UNITED STATES PATENT AND TRADEMARK OFFICE

APPLICATION NO.	FILING DATE	FIRST NAMED INVENTOR	ATTORNEY DOCKET NO.	CONFIRMATION NO.
10/623,803	07/22/2003	Arnold Keller	246472005200	5304
7590 Barry E. Bretschneider Morrison & Foerster LLP Suite 300 1650 Tysons Boulevard McLean, VA 22102		03/26/2007	EXAMINER RAMANA, ANURADHA	
			ART UNIT 3733	PAPER NUMBER
SHORTENED STATUTORY PERIOD OF RESPONSE 3 MONTHS		MAIL DATE 03/26/2007	DELIVERY MODE PAPER

DETAILED ACTION***Continued Examination Under 37 CFR 1.114***

See marked up Figures from Caenen et al. below, to clarify Examiner's interpretation of Caenen et al..

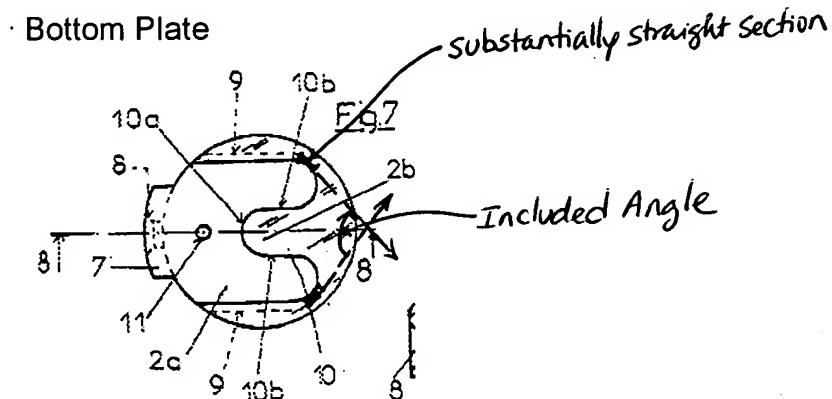
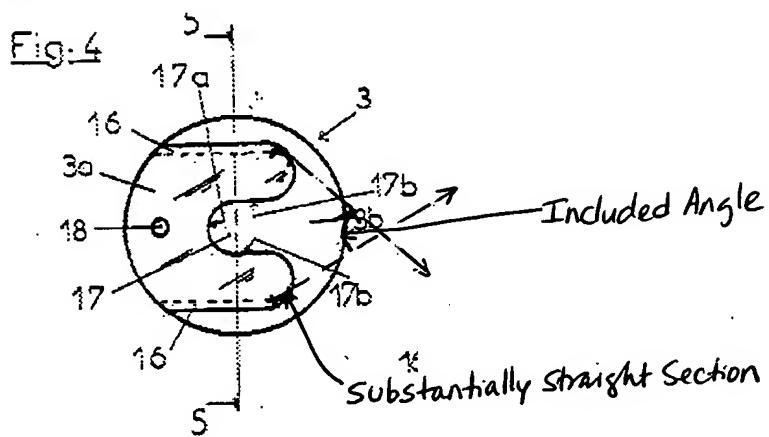
Caenen et al. disclose an intervertebral disc prosthesis including: two cover plates (1, 2) and a prosthesis core 3 connected to cover plate 2 by connection profiles undercut in a complementary manner wherein the connection profiles include at least a pair of substantially straight profile sections, i.e., profile sections that are largely but not wholly straight, disposed symmetrically with respect to an anterior-posterior direction of the prosthesis (Figs. 4, 5, 7 and 8 and pages 5-9 of the attached translation).

It is noted that lines could be extended from substantially straight sections where the undercut portions 9 curve inward such that the lines meet at an included angle not greater than 150 degrees. Similarly, lines could be extended

from substantially straight sections of undercut portions 16 such that the lines meet at an included angle not greater than 150 degrees.
